RECORD OF DECISION

Tutu WellfieldSite

United States Environmental Protection Agency
Region II
New York, New York
July 1996

A responsiveness summary is required by Superfund policy. It provides a summary of citizens' comments and concerns received during the public comment period, and the United States Environmental Protection Agency's (EPA's) and the Virgin Islands Department of Planning and Natural Resources's (DPNR's) responses to those comments and concerns. All comments summarized in this document have been considered in EPA's and DPNR's final selection of a remedial action for the Tutu Wellfield site.

Figure S-27

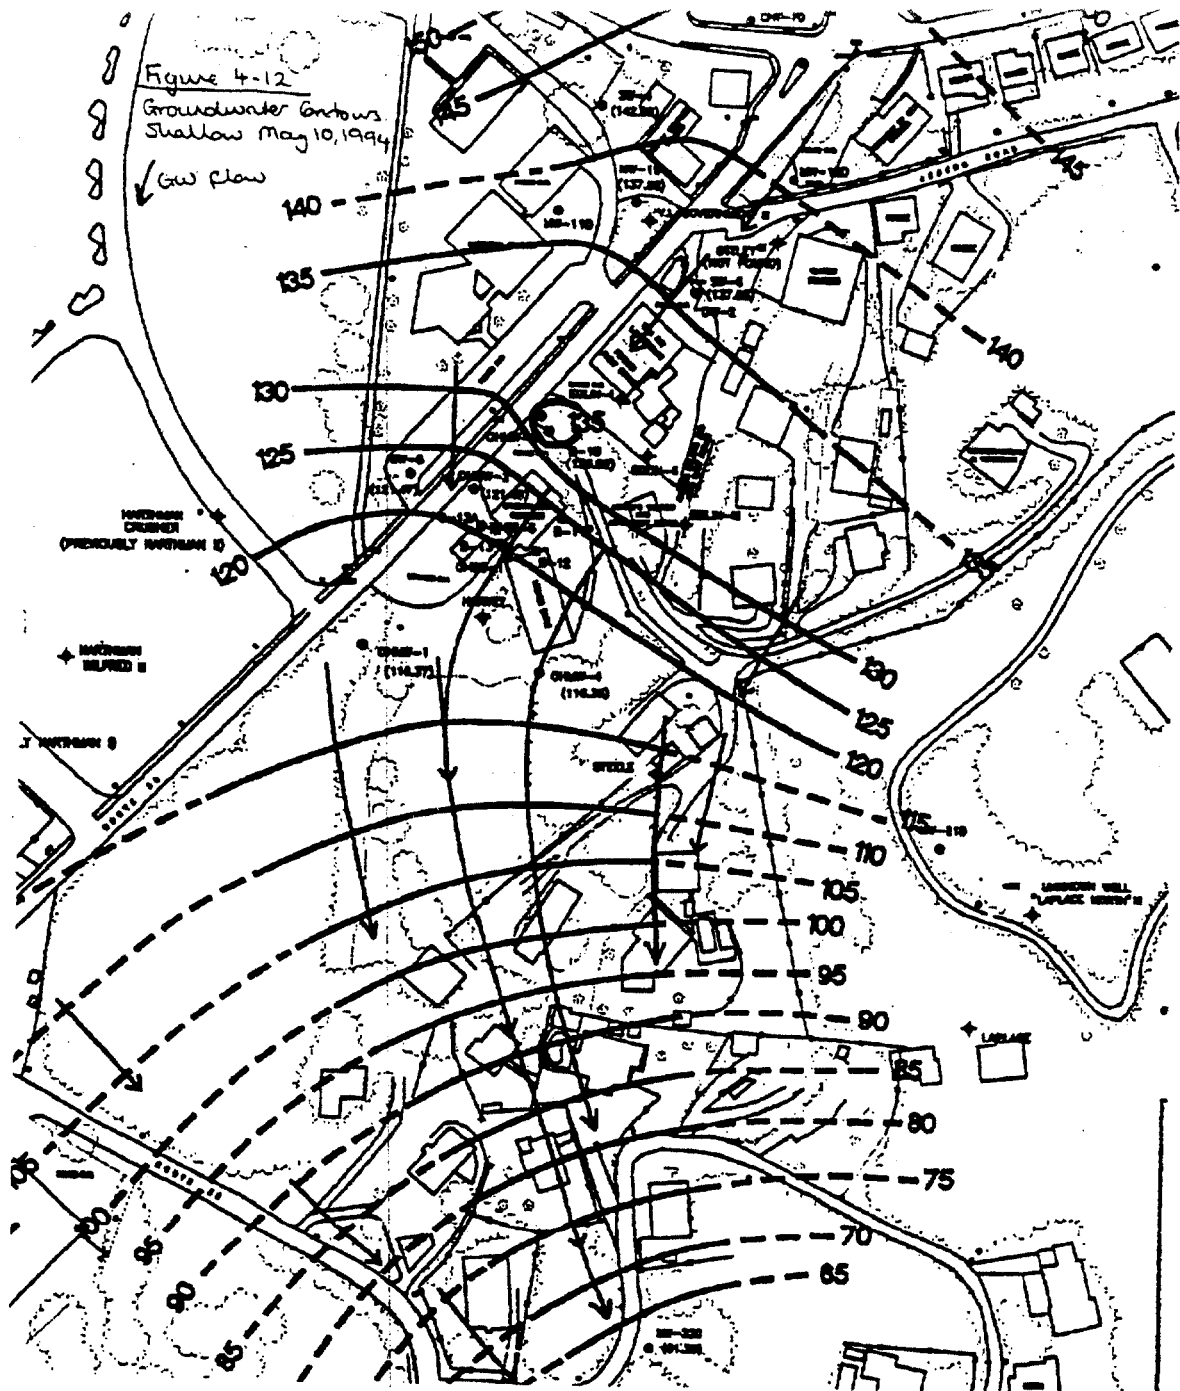
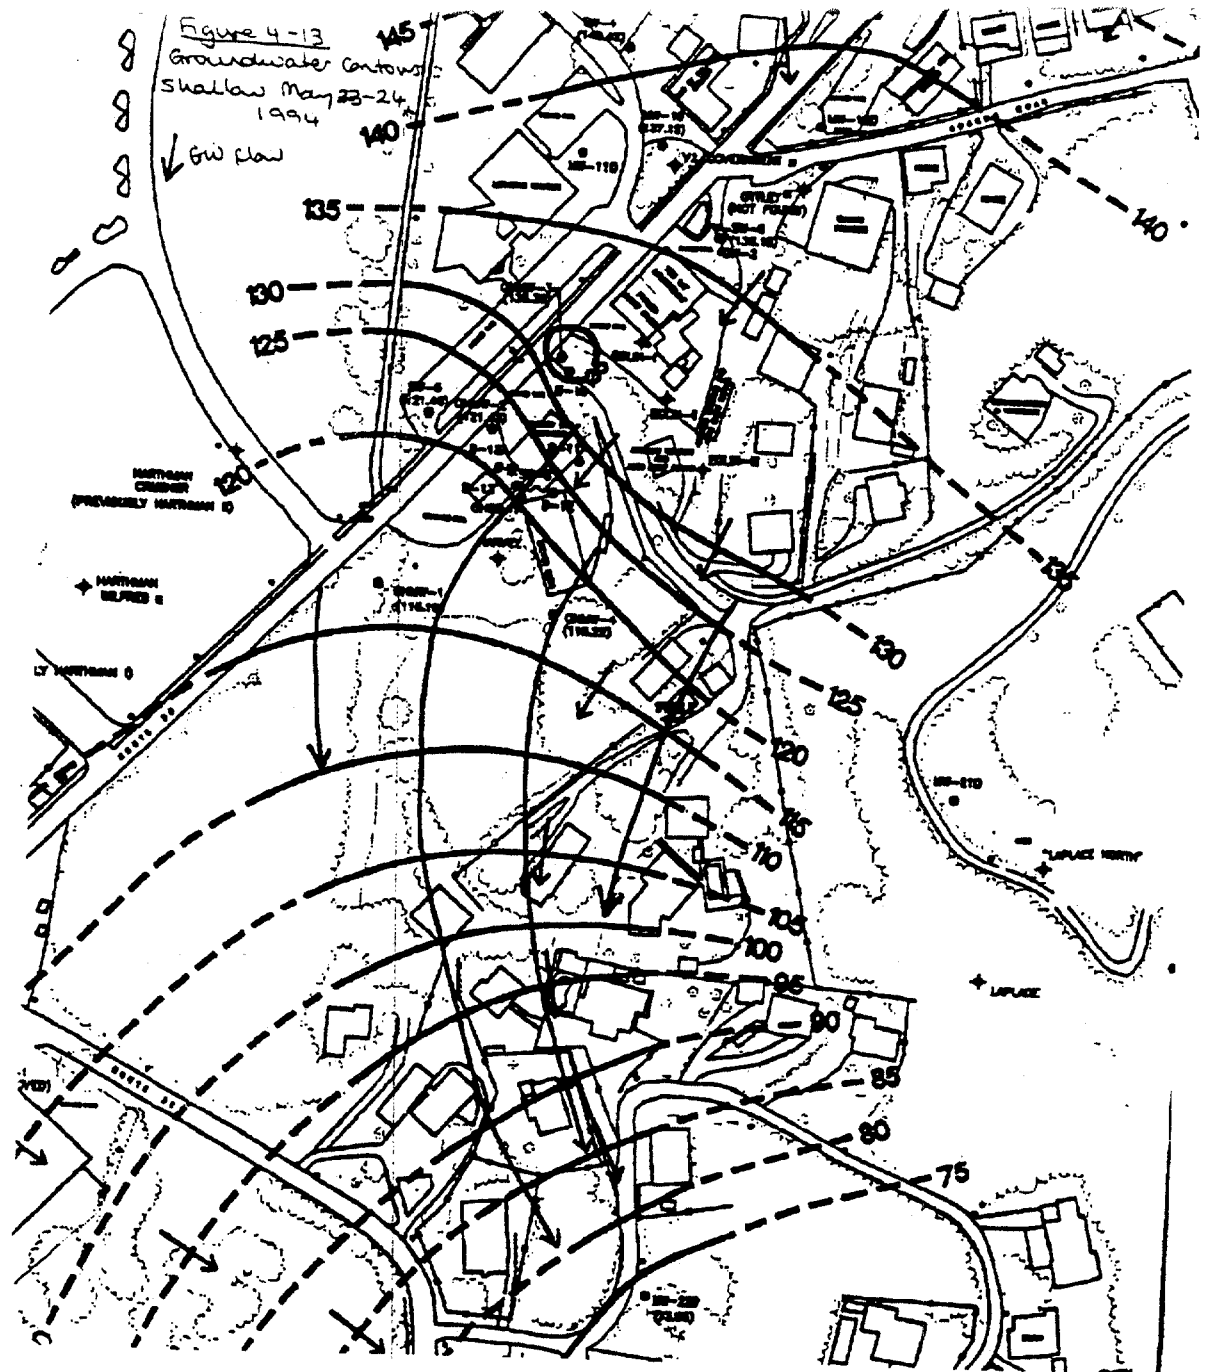
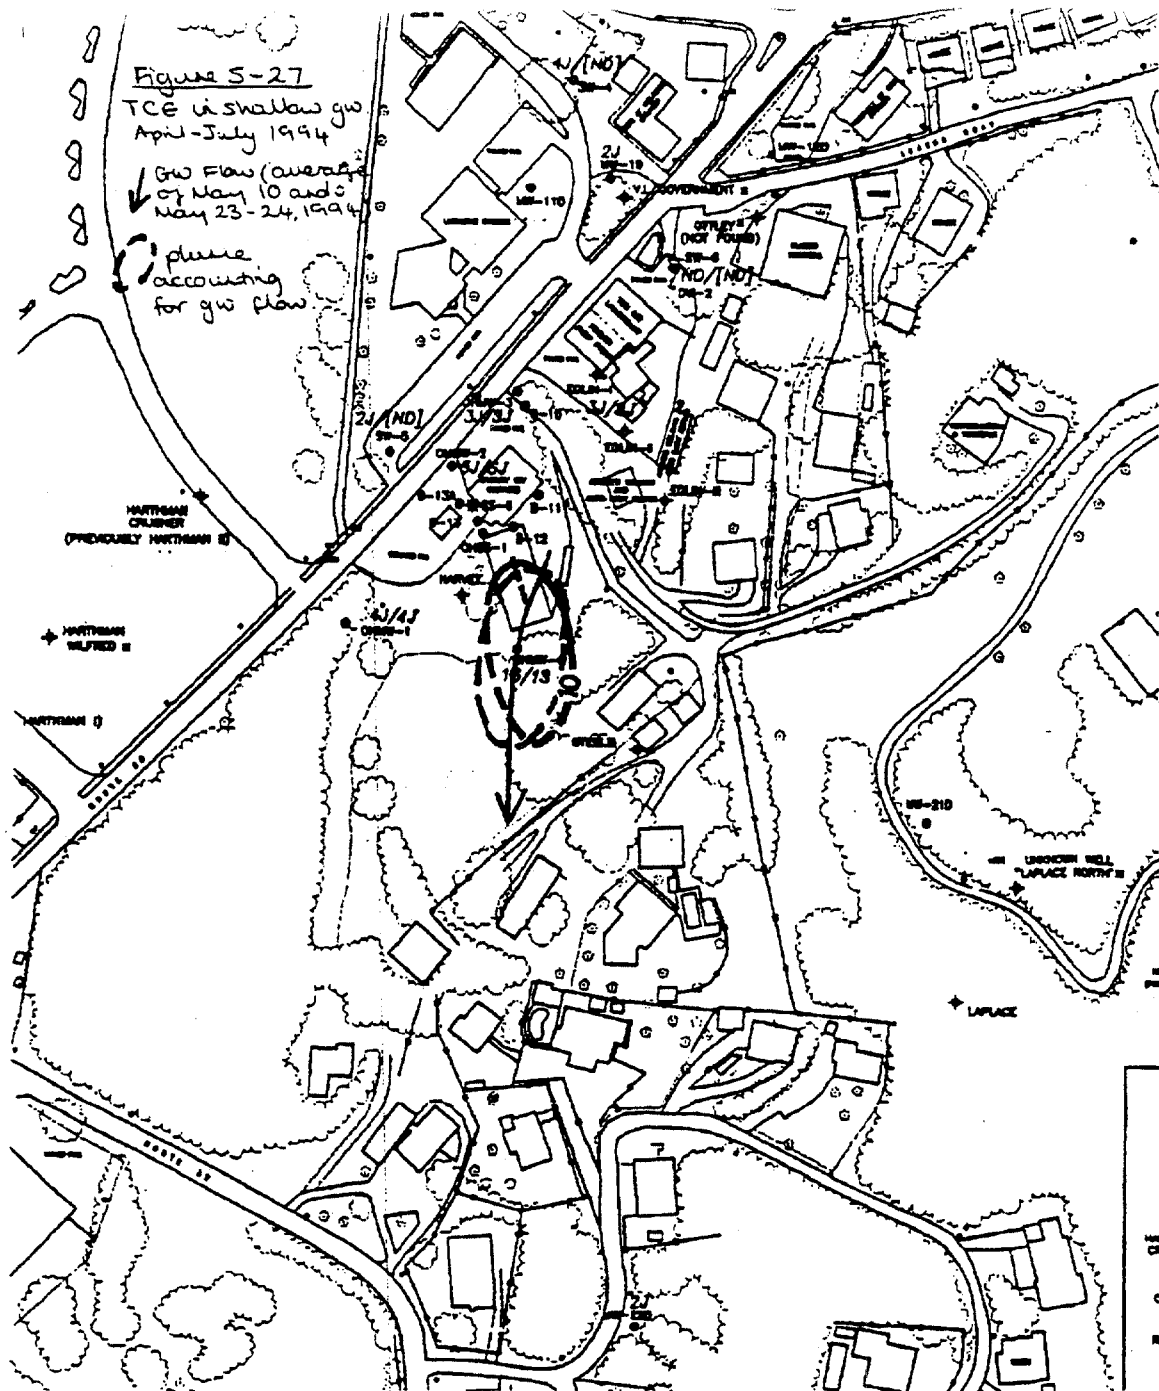
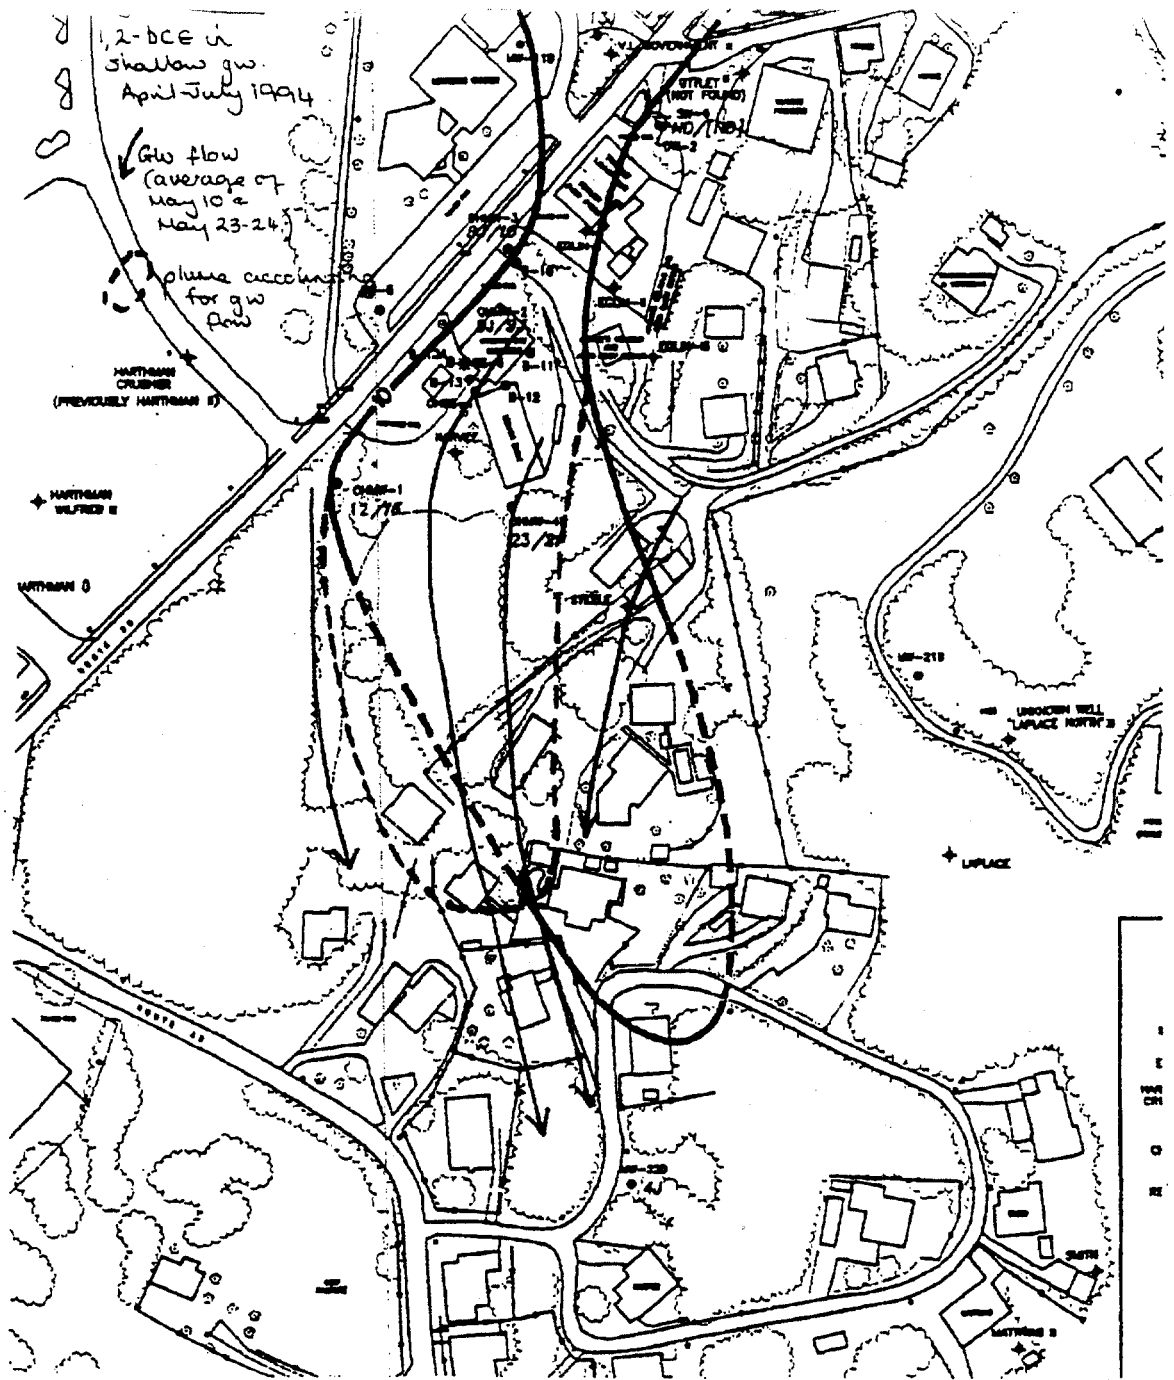
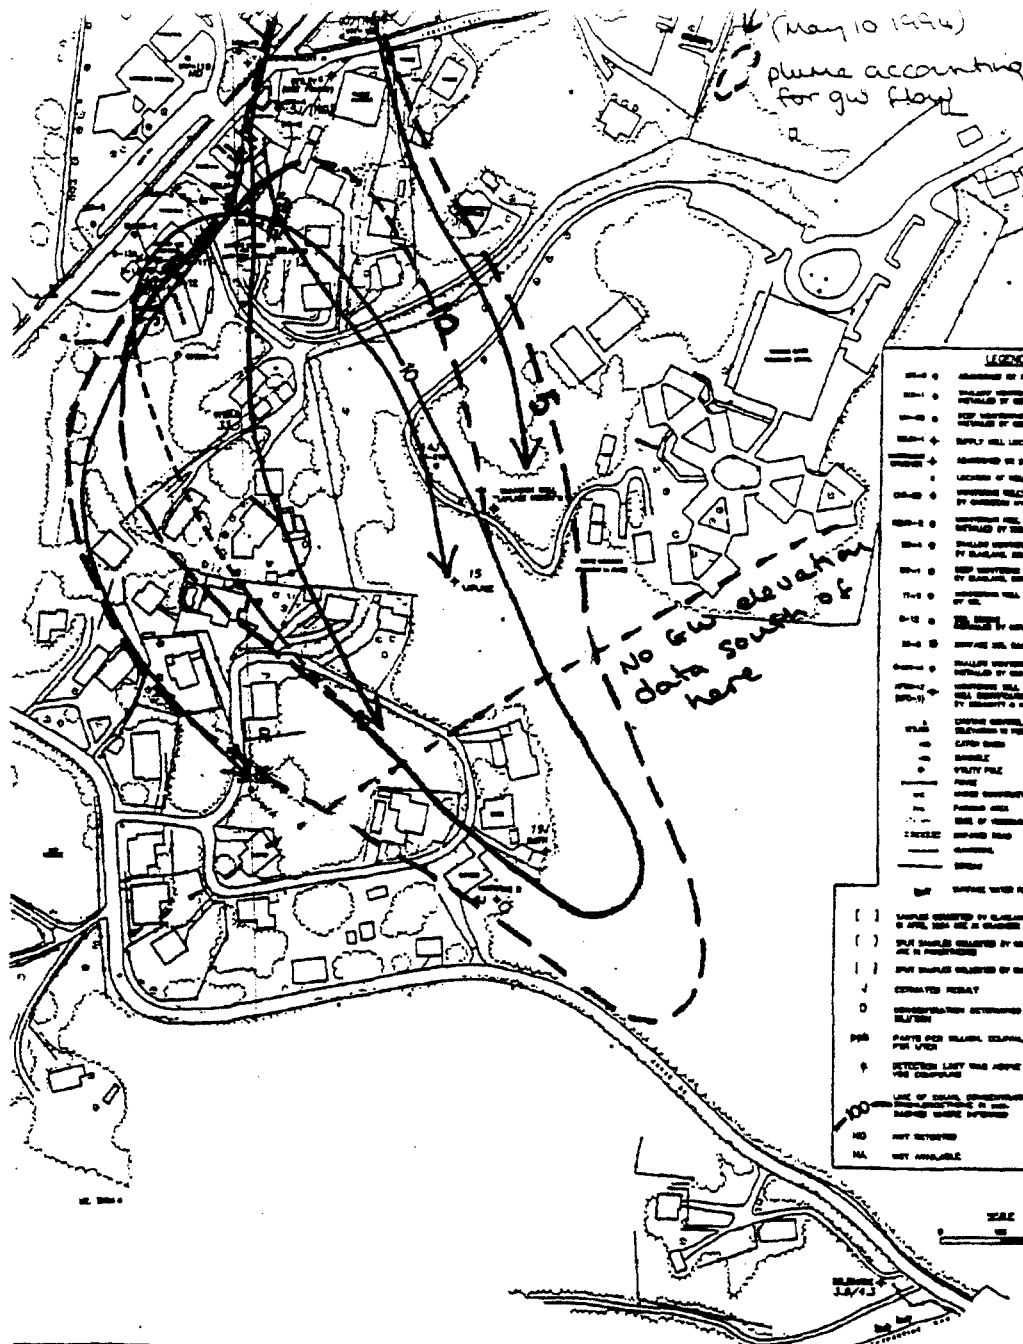
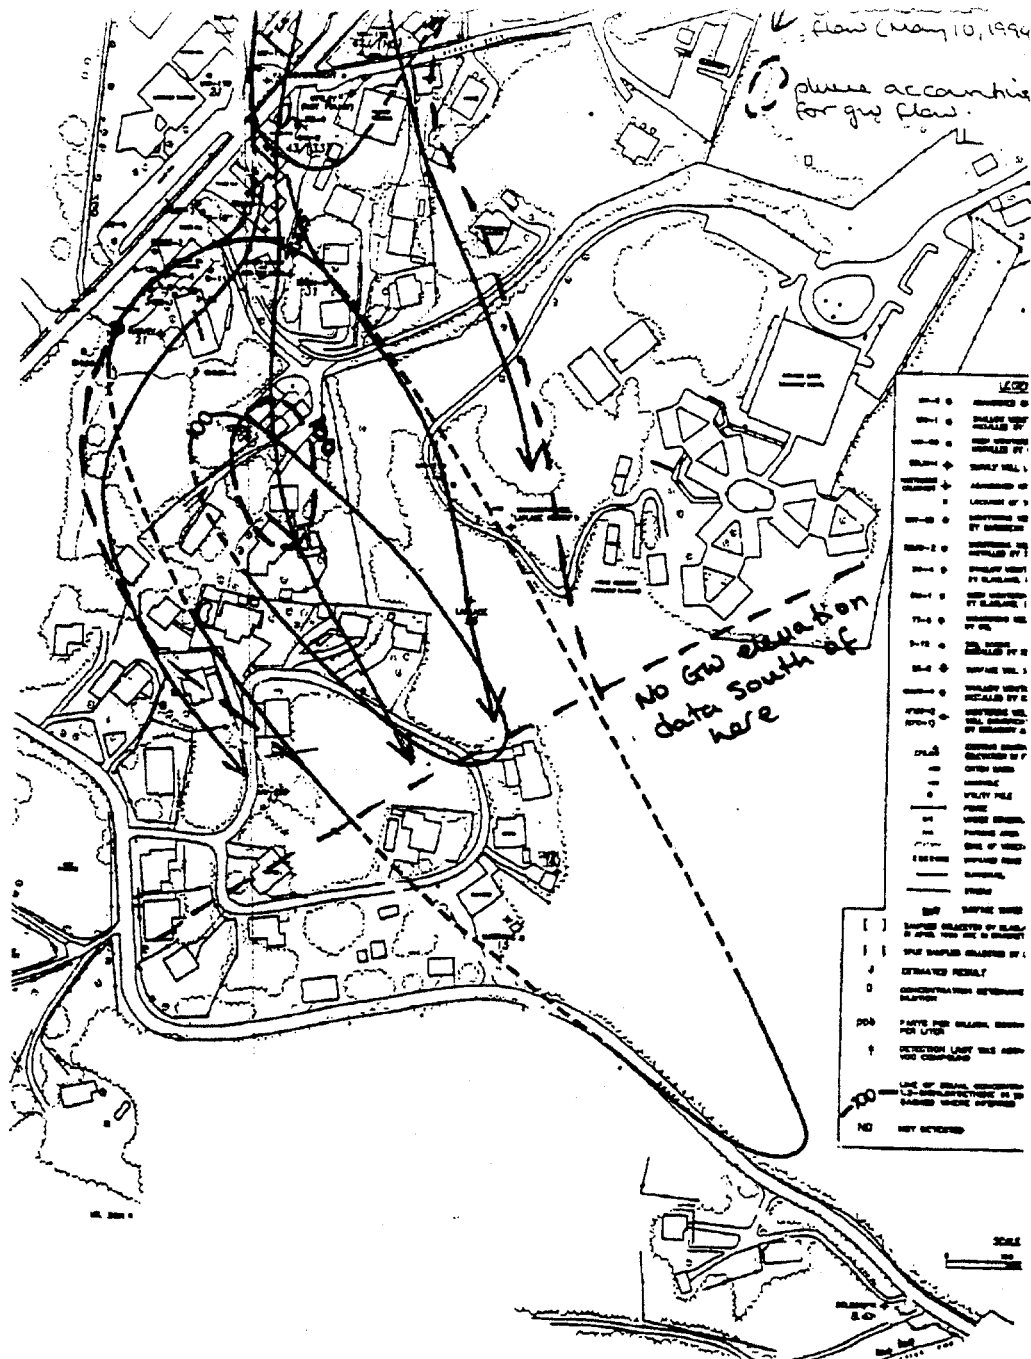
Eglin III wells. As demonstrated on the May 10, 1994 map, deep groundwater, and consequently contaminants, would flow southwest, beneath the O'Henry dry cleaning store. The flow path from the O'Henry dry cleaning store does not pass through the location of the Steele or LaPlace wells. Shallow groundwater flow is generally southwesterly in the vicinity of O'Henry. See, Exhibit 1, general comment 1 and attached depictions of the deep and shallow groundwater flow maps), Exhibit 2 Comment on Section 2.1.1.3.

The presentation of the TCE, PCE, AND 1,2 DCE in the deep groundwater is not consistent with the appropriate deep groundwater flow map as presented in the Report of the Remedial Investigation. A more consistent depiction of the plumes was submitted by IT with the comments on the Report of the Remedial Investigation. See, Exhibit 1, comment 2 and attached maps.

Further, there is a PCE hot spot located in the area identified as the "northern plume". This area, and its potential source has been ignored. In addition, if the accurate direction of groundwater is considered, it is impossible for a direct flow path to extend from the Harvey Supply Well to the Smith Supply Well. See, Exhibit 1, comment 1, and attached maps.
